Re: 998 Punchbowl Road

Urban Design Review of Planning Proposal

Council have engaged Annand Associates Urban Design (AAUD) to provide an independent Urban Design Assessment of a Planning Proposal at 998 Punchbowl Rd / 1499 Canterbury Road, Punchbowl.

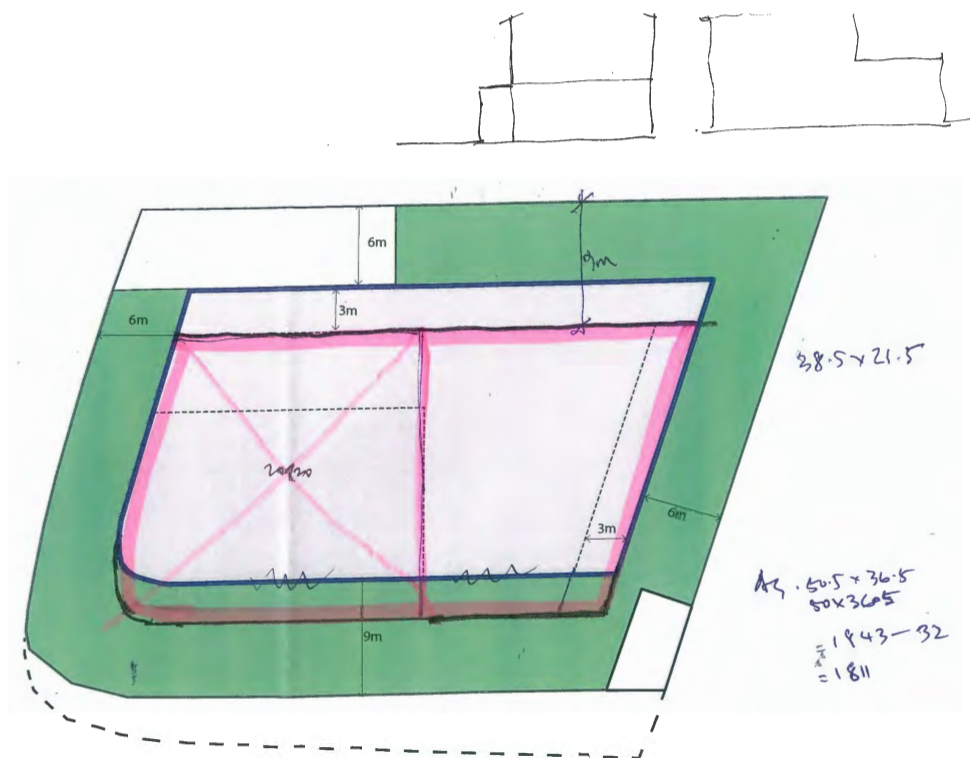
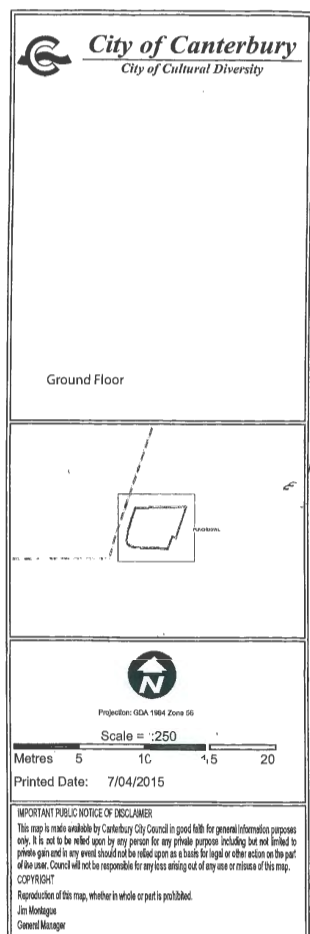
However, I still have a problem with an 8 storey building. This will provide a precedent for 8 storeys all along Canterbury Road, including the recent site at 642-644 Canterbury Road where we battled to get a mix of 4 & 8 storeys to limit overshadowing to adjacent residential properties to the south.

Thus, I would personally and professionally prefer a 6 storey height limit with capacity for some 8 storey in particular location, like a tower element on the "corner" (only) of Punchbowl Road.

Note also that inadequate communal space at ground level will require rooftop open space (ADG) and this must be accessible by lift and stair within the 25m.

Thus, I am comfortable agreeing to the setbacks proposed above however I would prefer a 6 storey building with an 8 storey corner and the maximum FSR of 2.5:1 (6/8 storey) rather than 2.8:1 (all 8 storey). An FSR of 2.8:1 is a dangerous precedent, particularly for the south side of the street.

Figure 19 :The site (with RMS dedication removed) and council setbacks applied

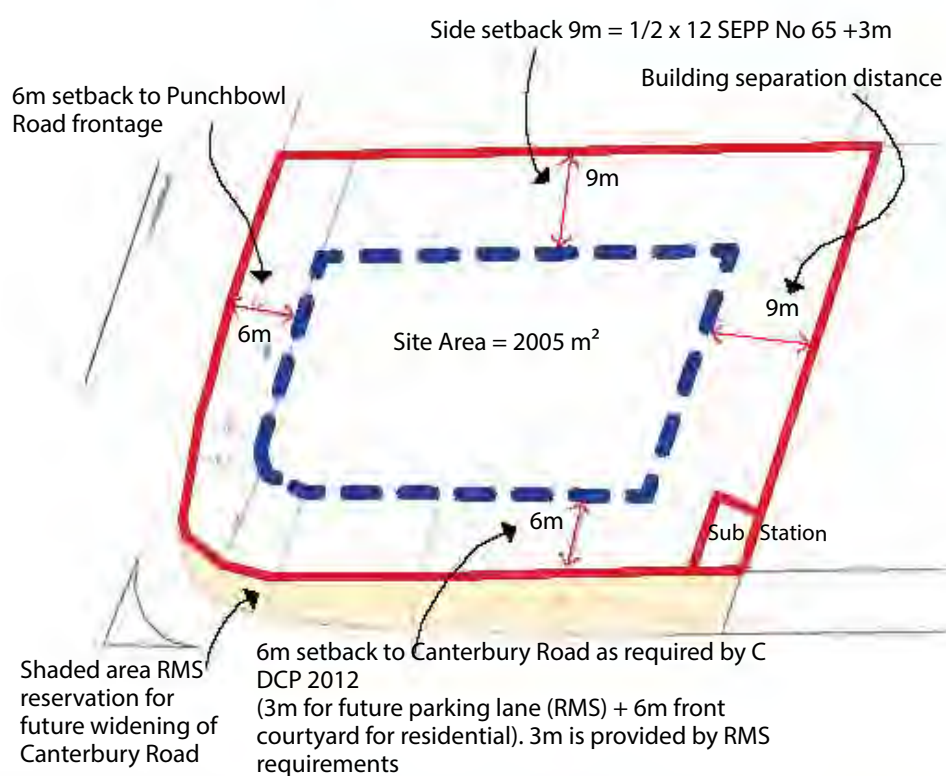
RMS requires dedication of a 4-5m strip as indicated access the complete frontage of the site to Canterbury Road (See figure 9)

Figure A1: Side Setback

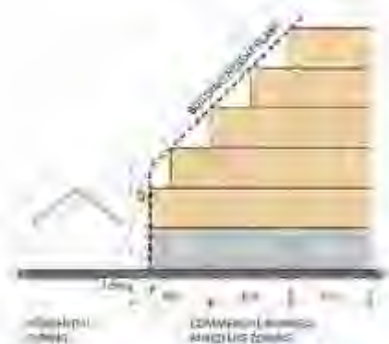
- The side setback could cause problems with adjacent residential zonings. This needs to be considered in the context of future development of adjacent sites.
- Building separation and setbacks required under SEPP 65 need to be complied with.
- 6m + 3m can be provided as specified in ADG.

COMMENT: Able to comply with redesign.

Figure A2: Rear Setback

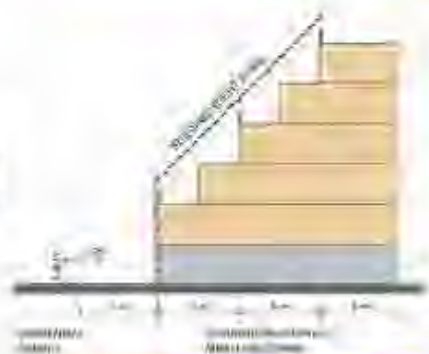
- Boundary with residential zone
- 45° from residential boundary fence top (1.8m)
- See above

COMMENT: Able to comply see above.

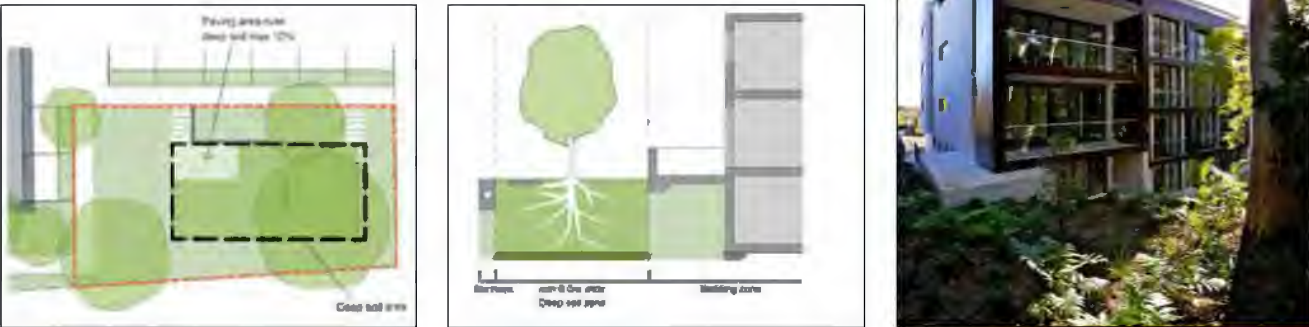
In order to clearly indicate how the interface works, where there is deep soil potential, how public activation and /or surveillance is to be achieved, and how buildings interact with the street.

COMMENT:
The proposal does not provide for a usable communal open space.
This should be reviewed. It is suggested that it will be provided as roofgarden. Clarification is also required in terms of levels, interface with surrounding residences, landscape design, function and community amenity and location of and soil depth of planters for internal tree planting. Note that a communal roof garden is essential.

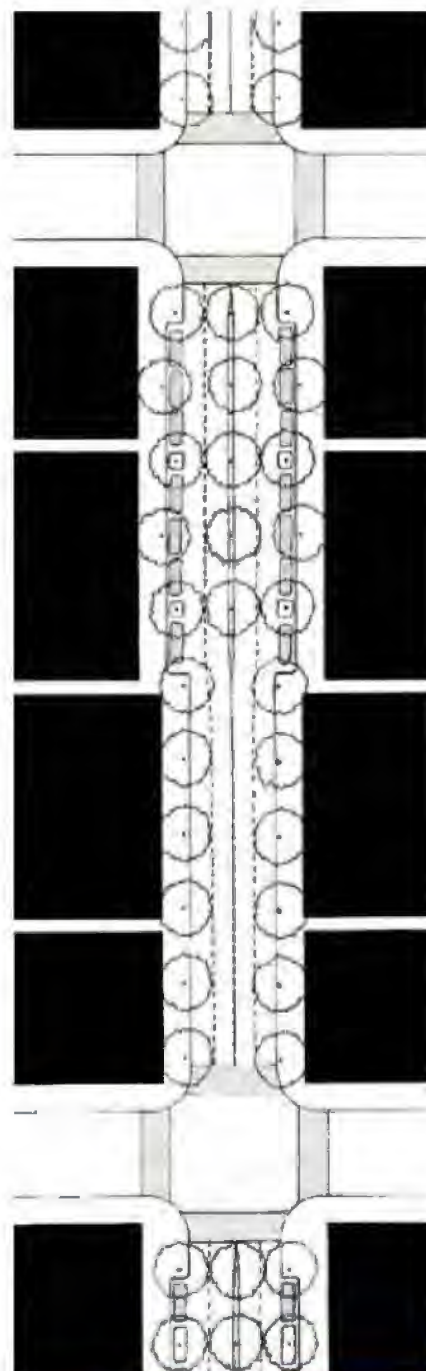
Vehicular access to and from Canterbury Road fronting sites is discouraged.

Access will be required from Punchbowl Road.

COMMENT: This can be provided by the proposal.

Figure 18- Option A

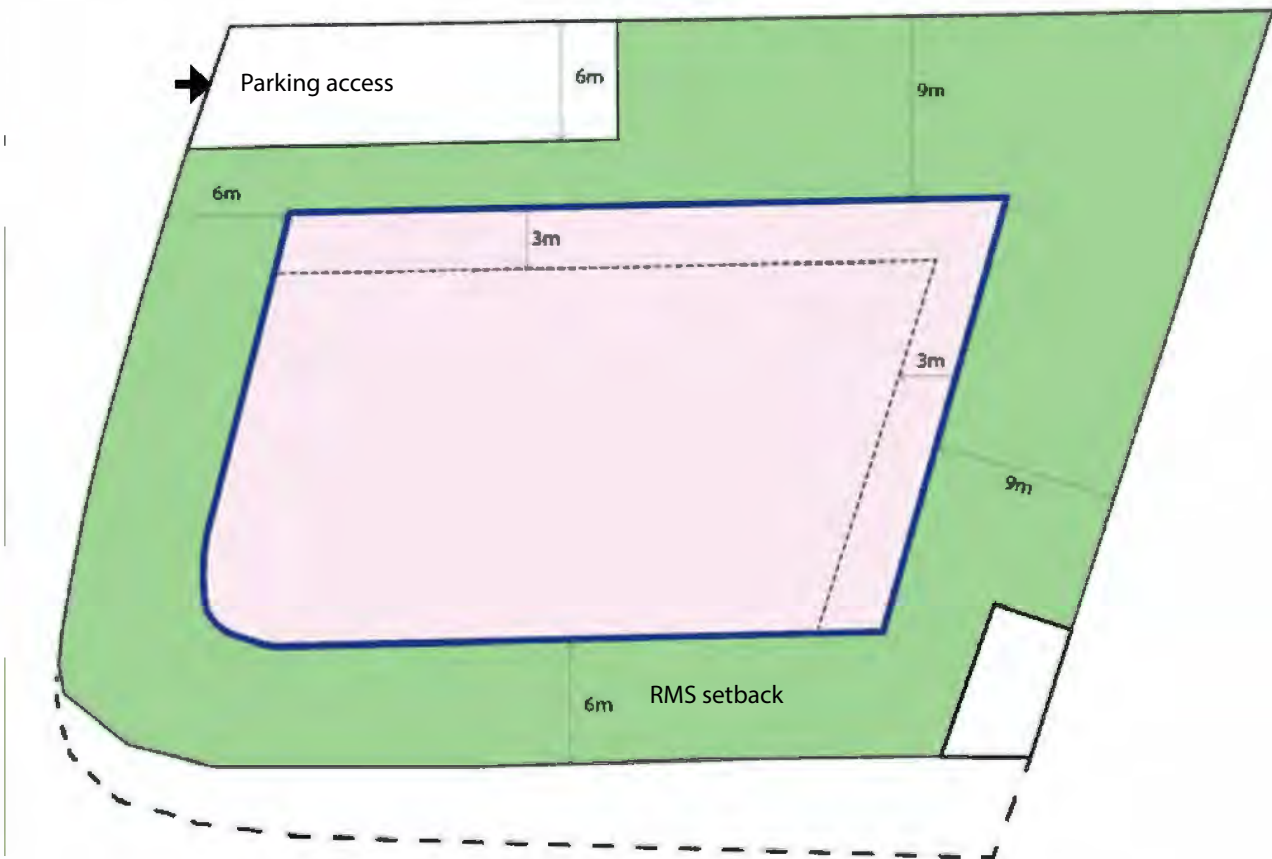
A: Compliant SEPP No 65 setbacks and roof garden common open space and RMS setback are able to be provided.

This option will generate an FSR of approximately 2.8:1 , however it requires communal open space either in the 9m setback which is inadequate or as a roof garden or both. This is acceptable but may establish a precedent for this section of Canterbury Road.

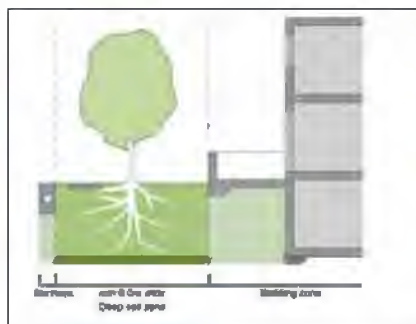
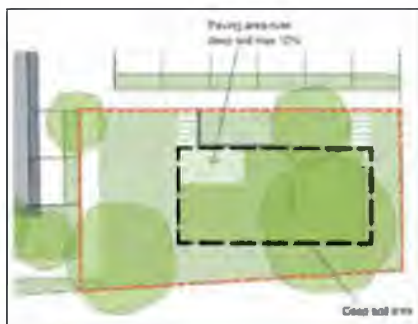
The proposal does not provide for a usable communal open space. This should be reviewed. It is suggested that it will be provided as roofgarden. Clarification is also required in terms of levels, interface with surrounding residences, landscape design, function and community amenity and location of and soil depth of planters for internal tree planting. Note that a communal roof garden is essential.

Figure 2: Review of Applicant's submission and recommendations for setback compliance (from the Urban Design Report)

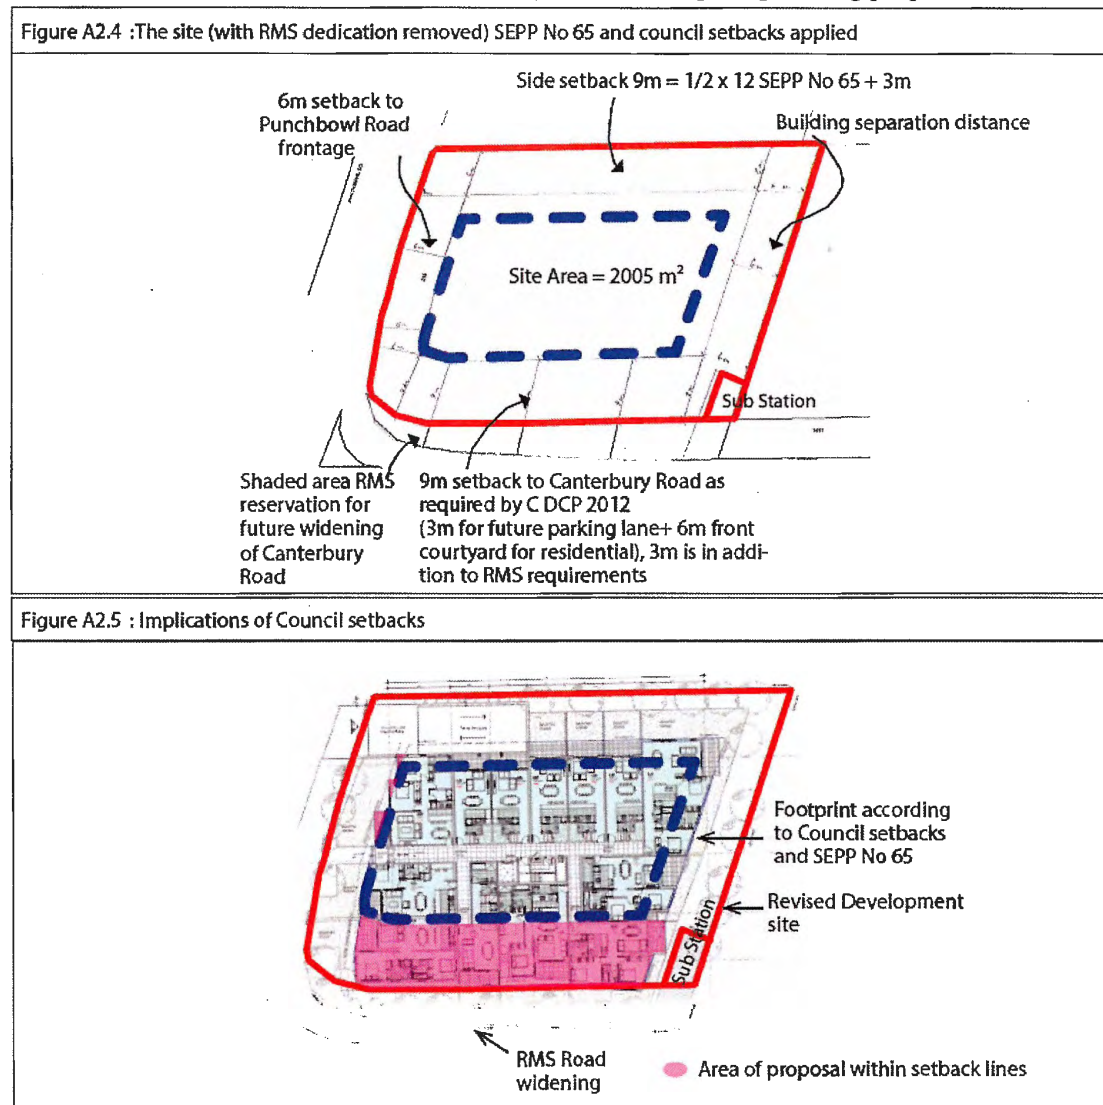
The following diagrams excerpted from the urban design report prepared by Annan d Associates in August 2015 show the analysis of the original planning proposal :

A compliant design outcome could be achieved by implementing the following improvements to the submitted design:

Figure 3: Revised building footprint to achieve compliant design solution (from the Urban Design Report)

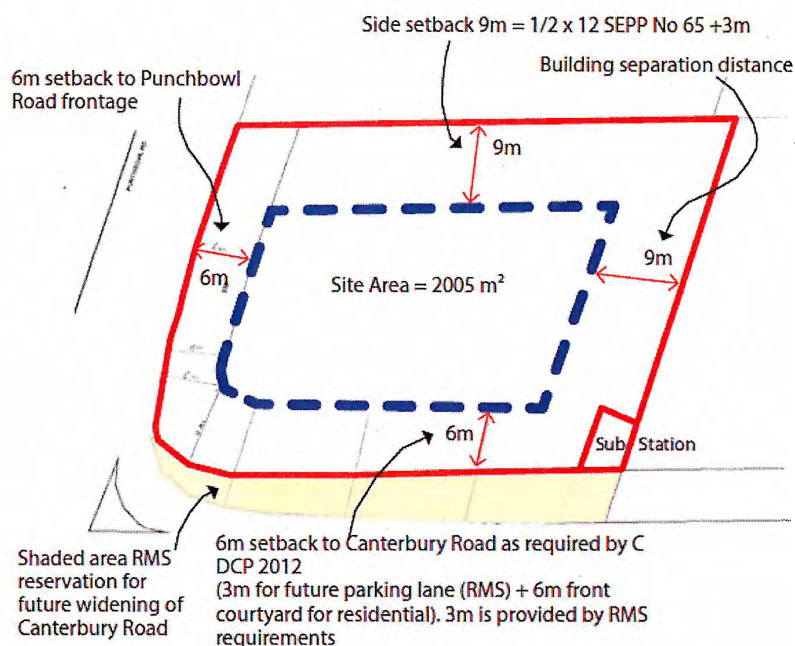
- Maintenance of 5 storey height across the area contained within the building envelope described by the applicable setbacks.
- Improvement in the site interface with Punchbowl Park and communal open space by increasing the communal open space in the north-eastern corner of the site.

A revised development design that would achieve compliance with SEPP 65, the Apartment Design Code, Canterbury LEP 2012 and Canterbury DCP 2012 would result in a development with a maximum building height of 15 and a corresponding Floor Space Ratio of 1.5:1 (less than the recommendation for the site of 2.2:1). This is largely due to the site being on a corner, slightly irregular in shape and adjacent to lower density developments, which require greater setbacks than originally proposed by the applicant to achieve compliance with the provisions of SEPP 65 (including the Apartment Design Guide) and Council development controls.
